**APPLICATION FOR PERMISSION
UNDER SECTION 16 OF
THE TOWN PLANNING ORDINANCE
(CAP. 131)**

From: charles [REDACTED]
Sent: Tuesday, February 25, 2025 10:18 AM
To: Jackin Ho Yeung YIP/PLAND [REDACTED]
Subject: RE: A/SK-HC/366 取代 2 月 18 號, 2 月 19 號, 2 月 21 號及 2 月 25 號的電郵及補充有關 Lot No. 505 申請的資料

寄件者: charles <[REDACTED]>
寄件日期: 2025年06月11日星期三 16:54
收件者: Sally Sin Yi CHAN/PLAND
副本: [REDACTED]
主旨: RE: Application No. A/SK-HC/366 - Proposed Temporary Office with Ancillary Car Park for a Period of Three Years at Lot 505 in D.D. 210 and Adjoining Government Land, Luk Mei Tsuen Road, Ho Chung, Sai Kung
附件: attachement 2.pdf; attachement 3.pdf; attachement 1.pdf
類別: Internet Email

SITE PLAN

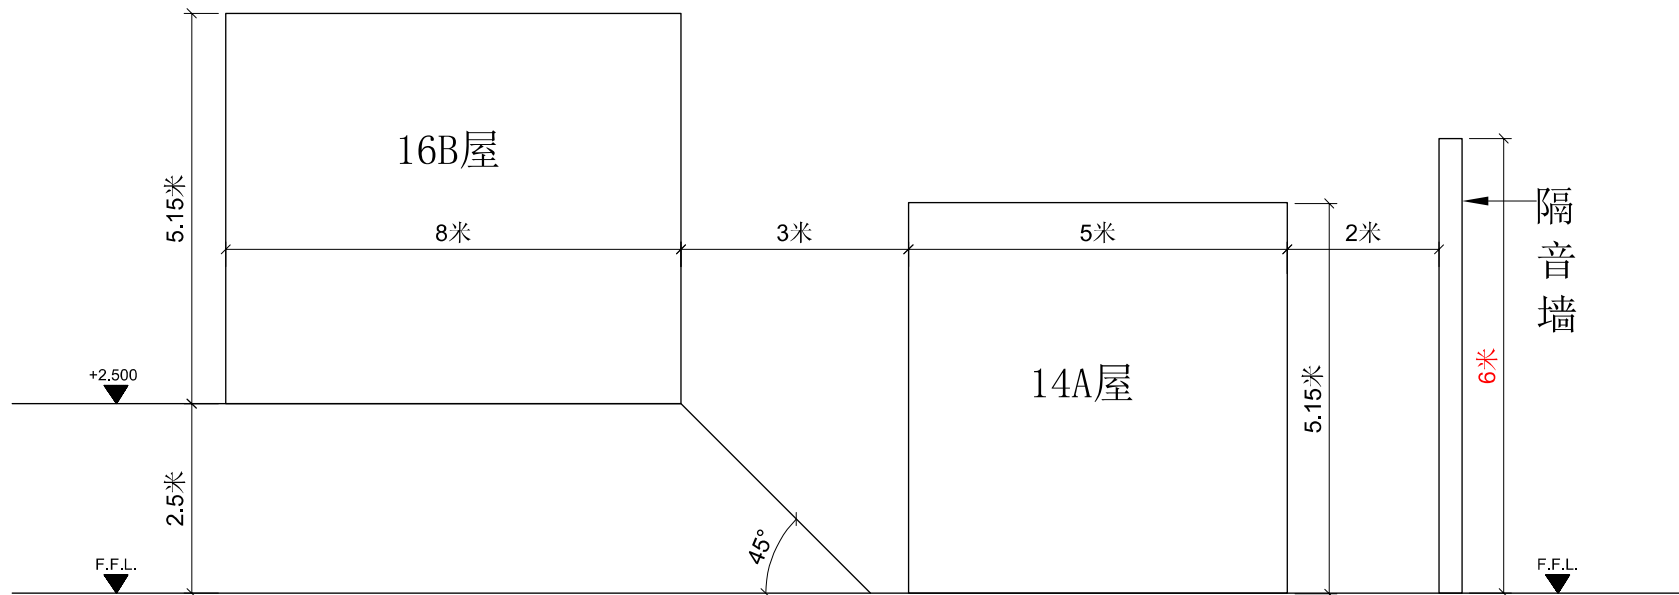
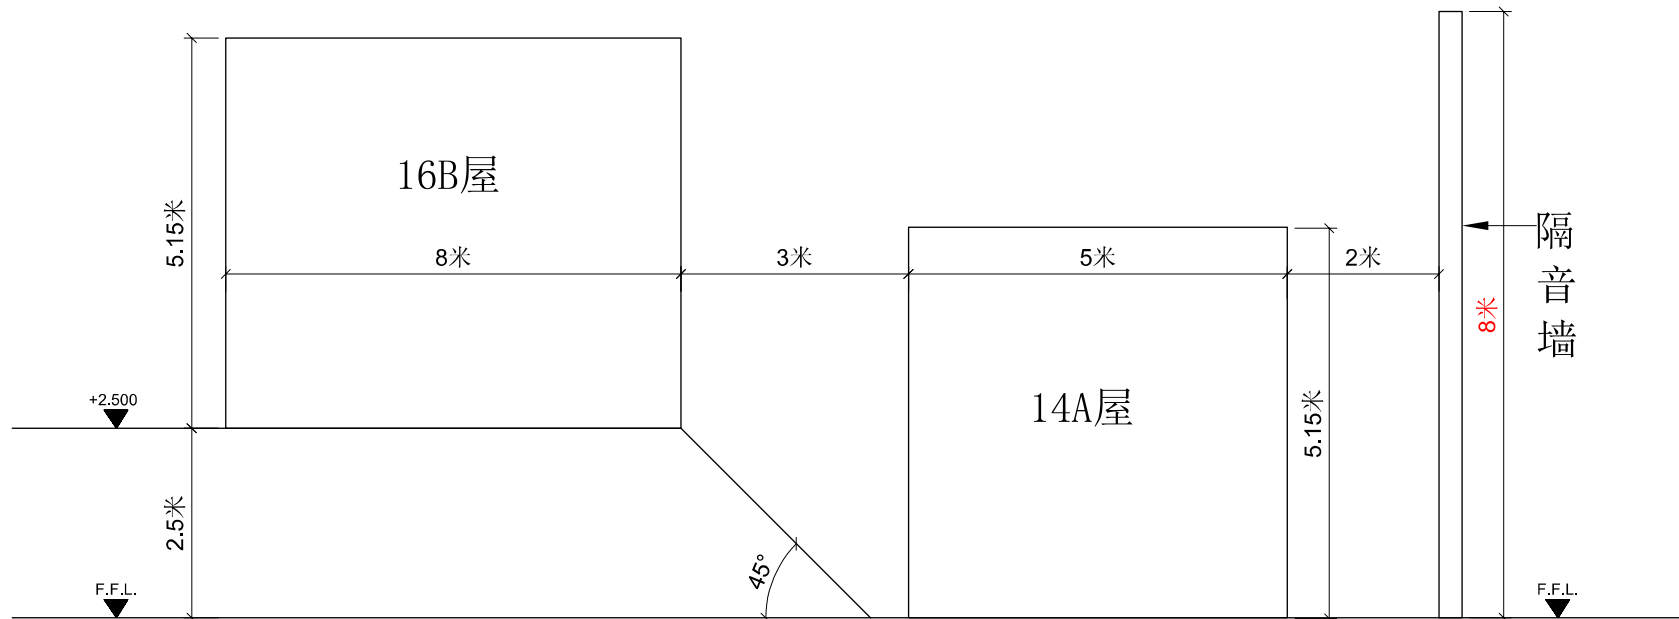
Refer to the comment from Planning Department.

1. Building materials trading company.
2. Car park had been revised to 1no.
3. Heavy vehicle parking space had been cancel.
4. Land Department had been notice will be using boundary fencing to adopted in between G.L. and Lot 325 RP.

SWEPT PATH

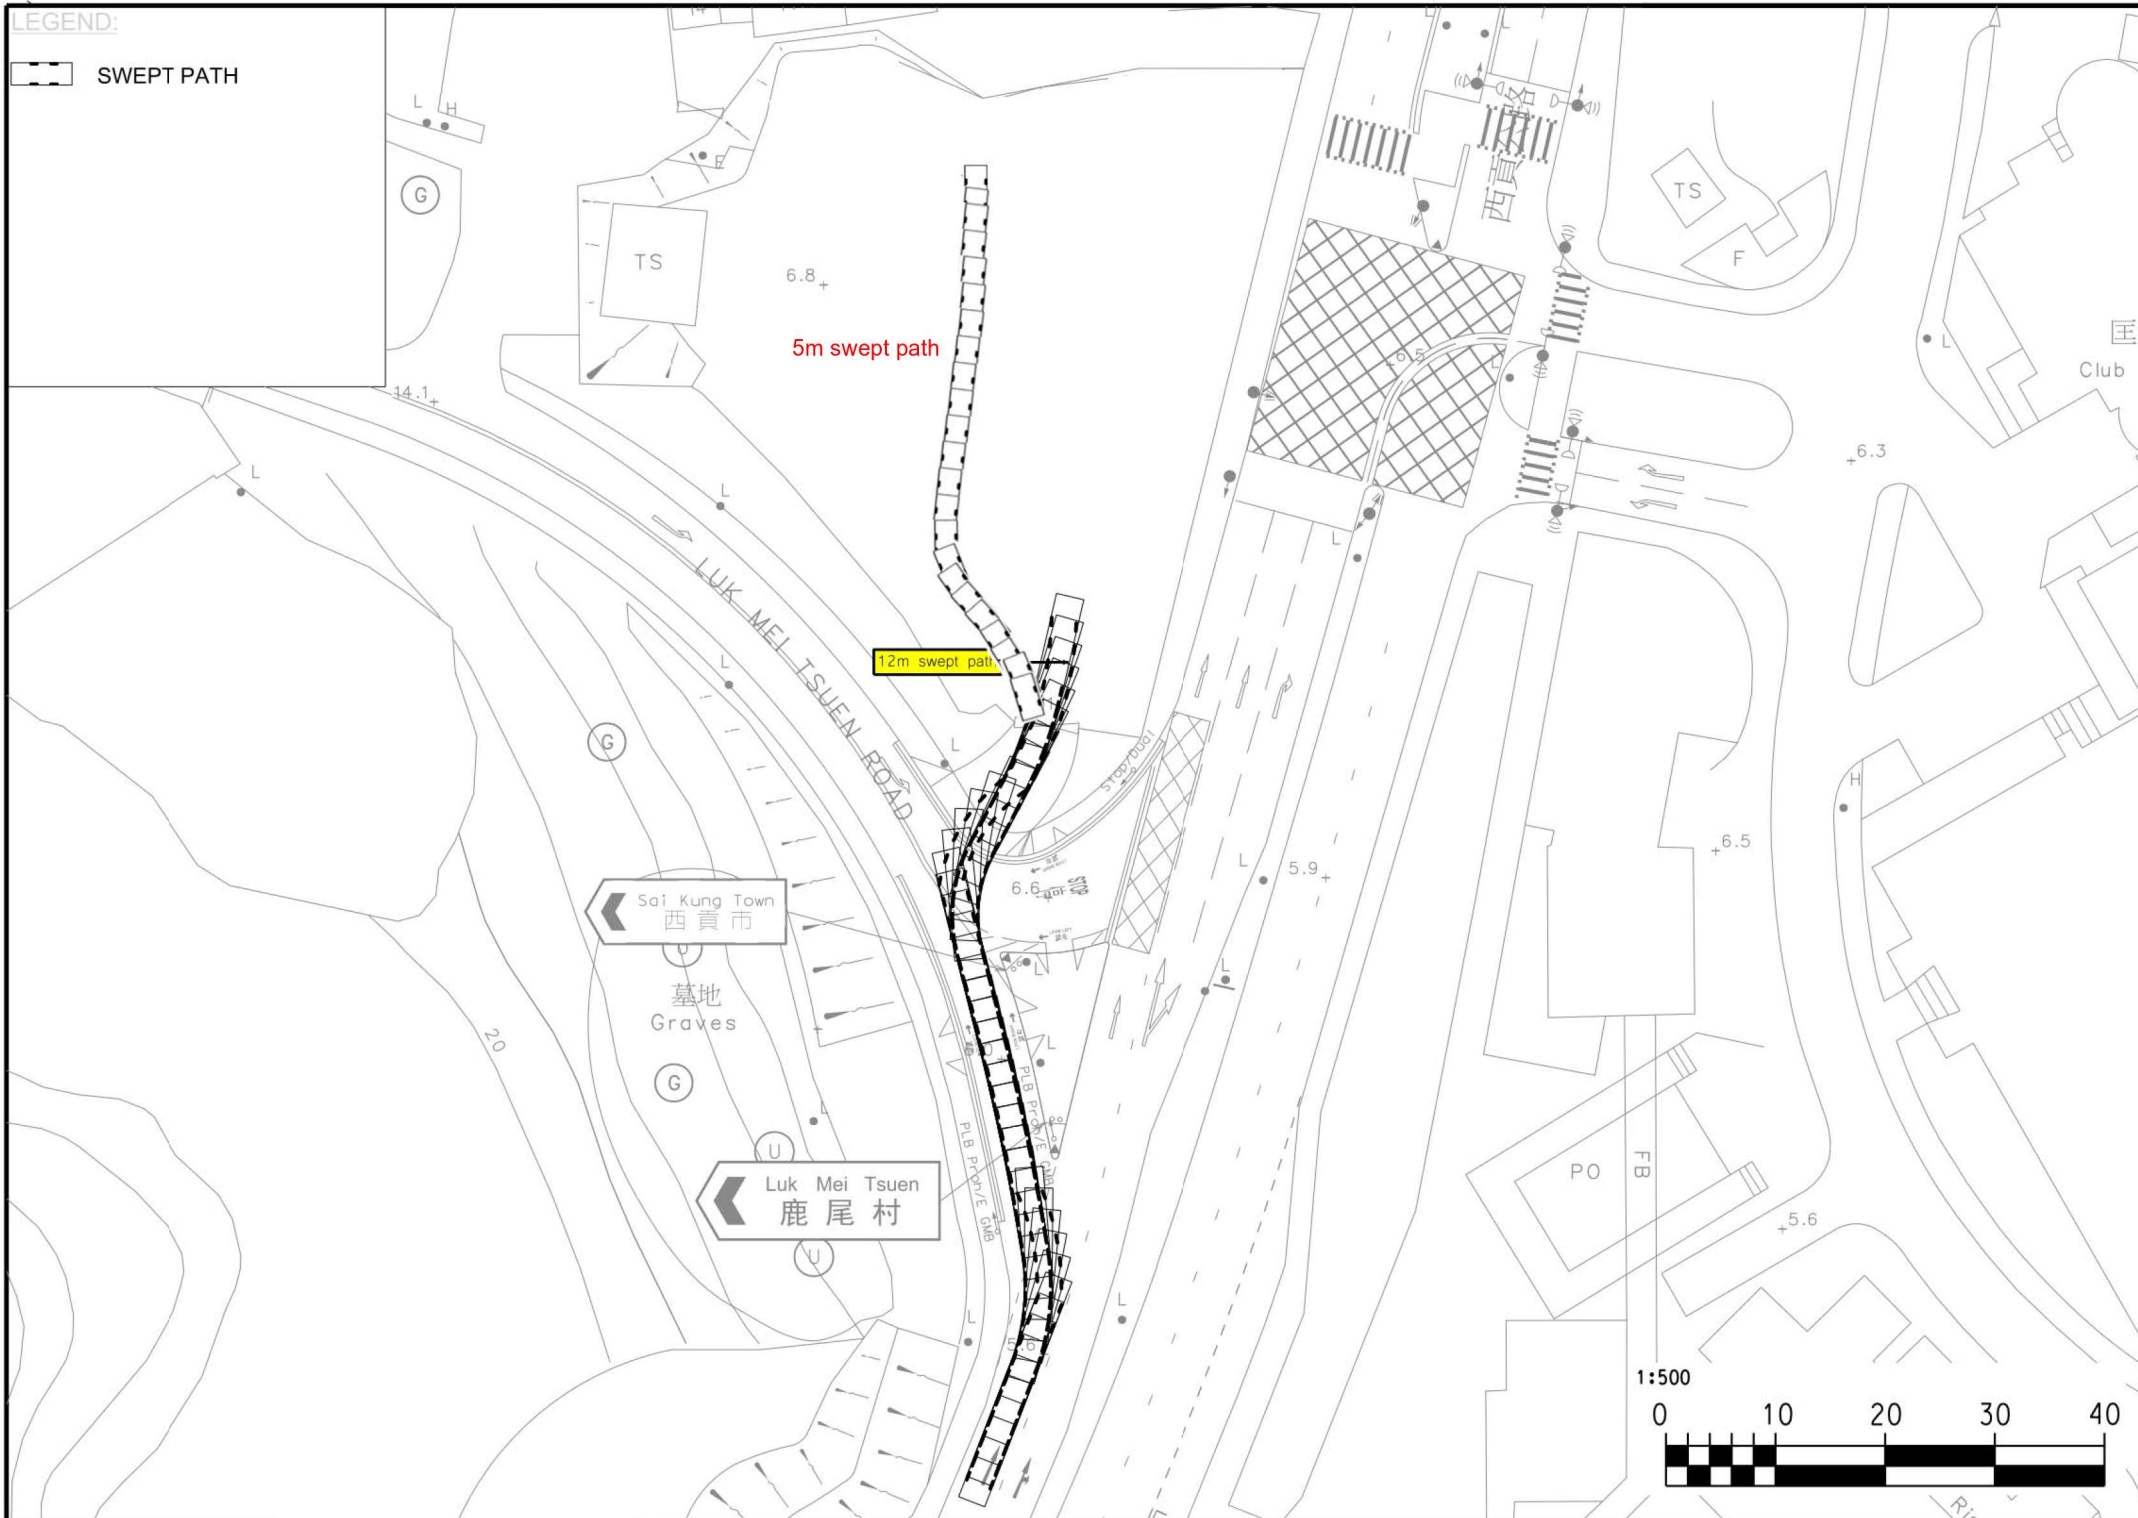
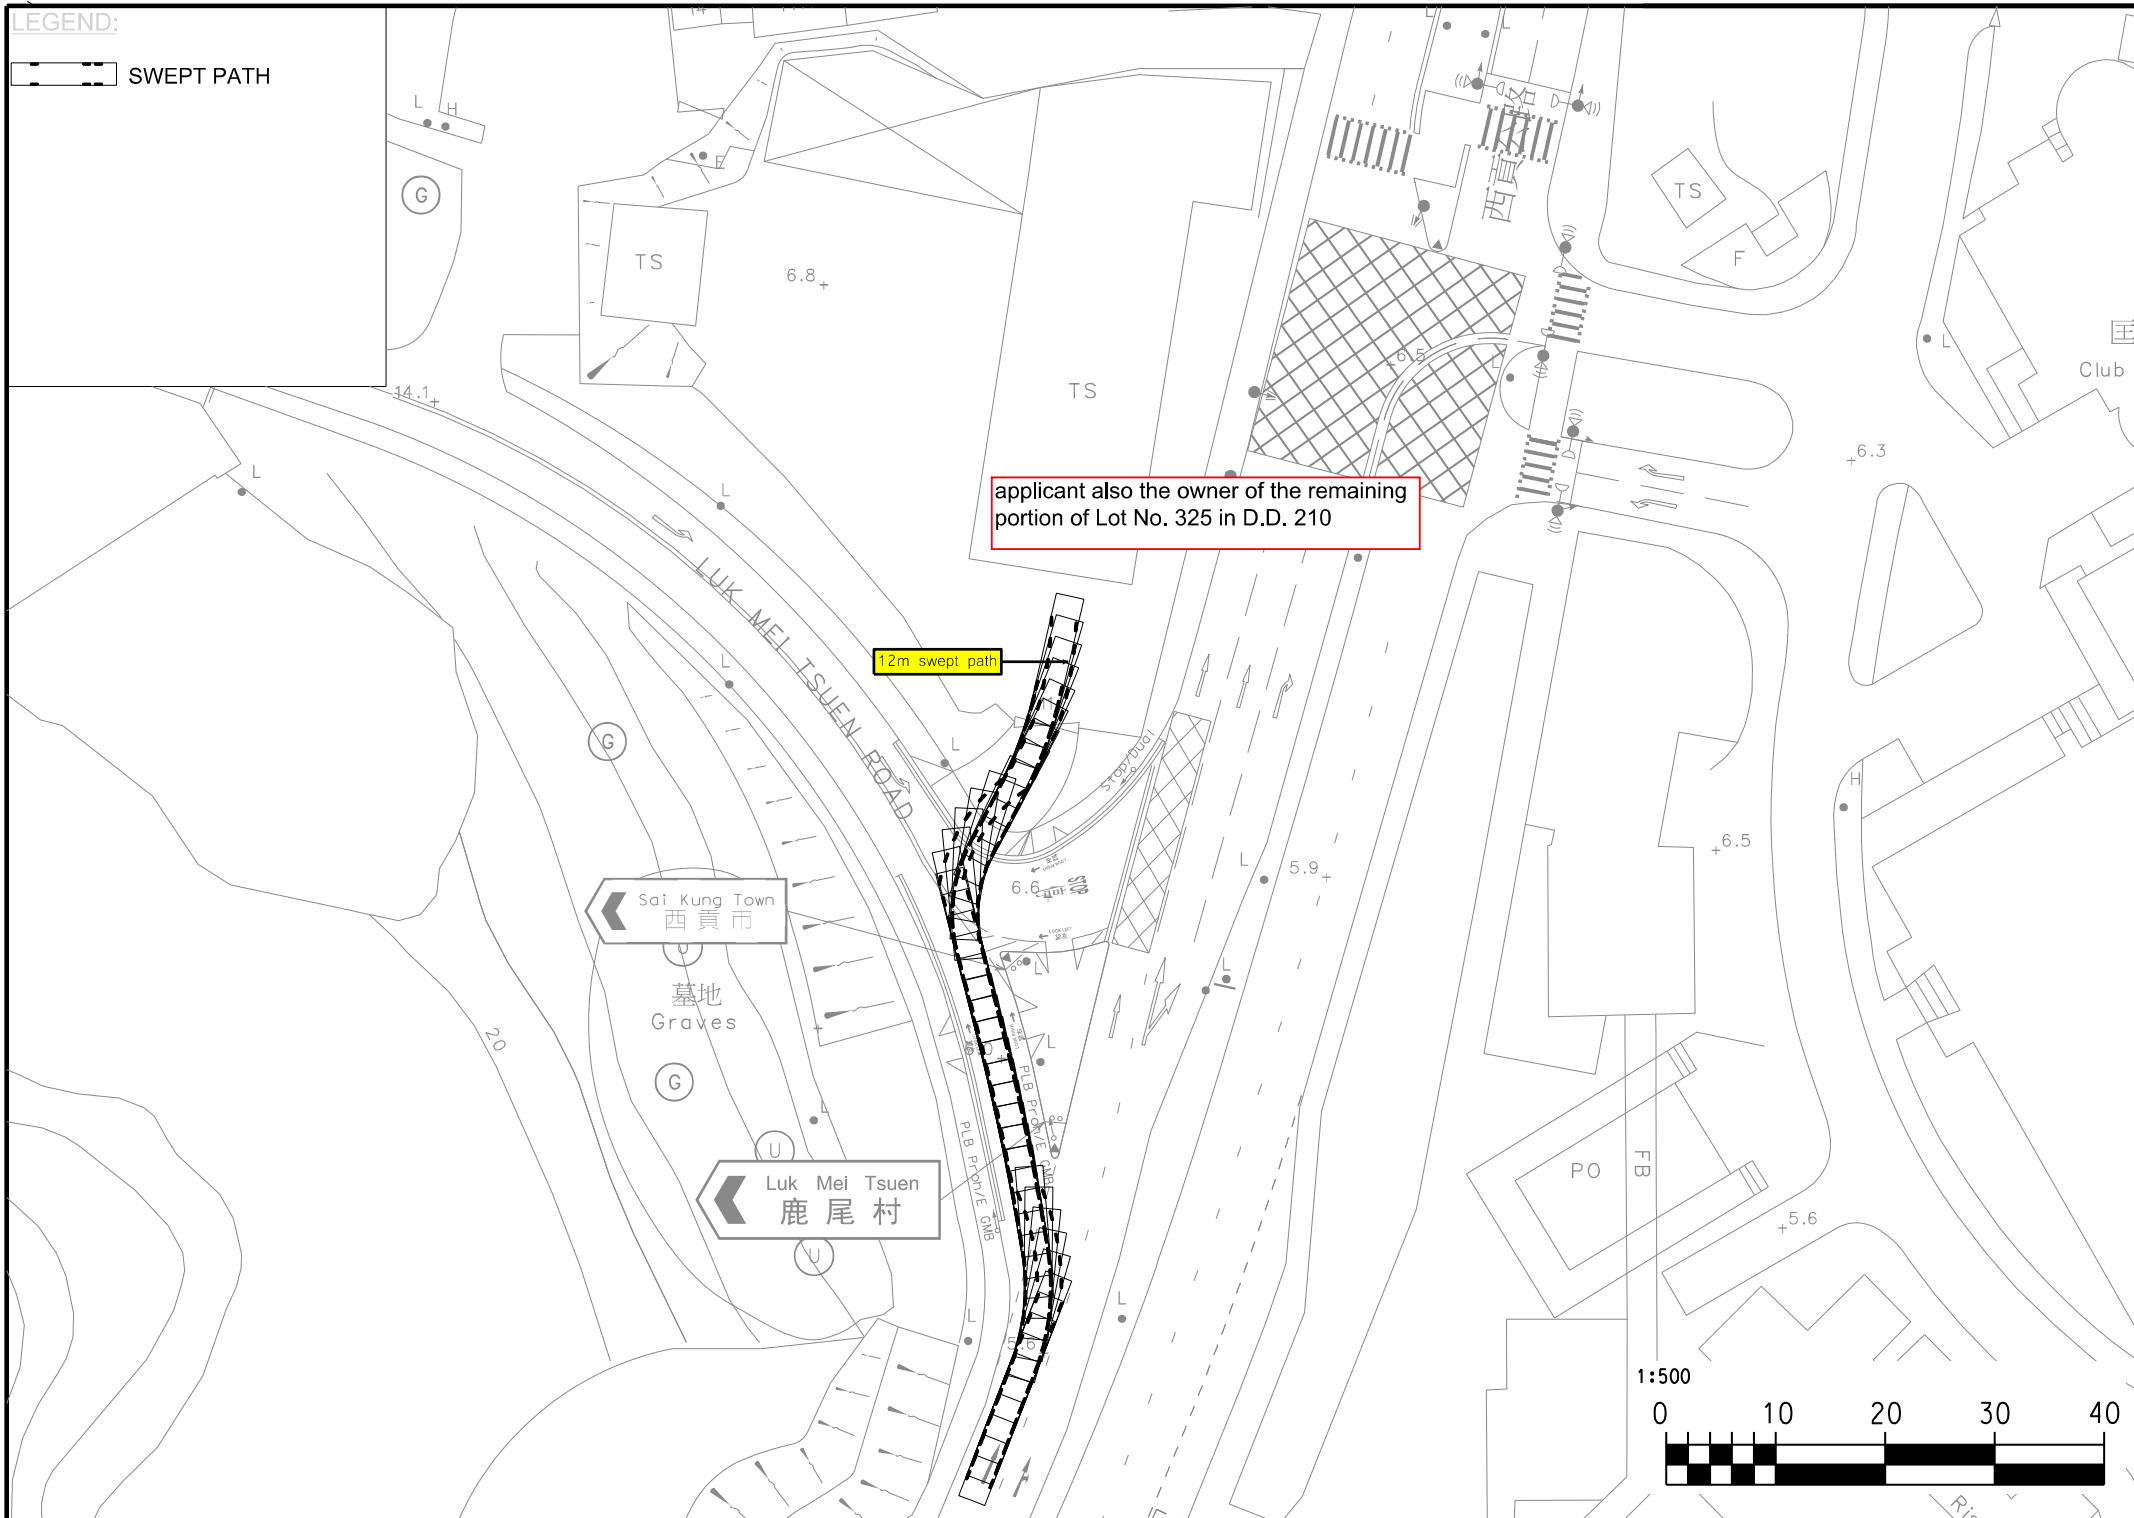
Refer to the comment from Transport Department.

1. Attached swept path analysis.
2. Our dimension of parking spaces should comply with planning standard
3. Enclosed with revised layout plan, according to the layout plan, there will be 1 no. of car park and 1 no. of loading/unloading space.
4. Attached swept path for car park.
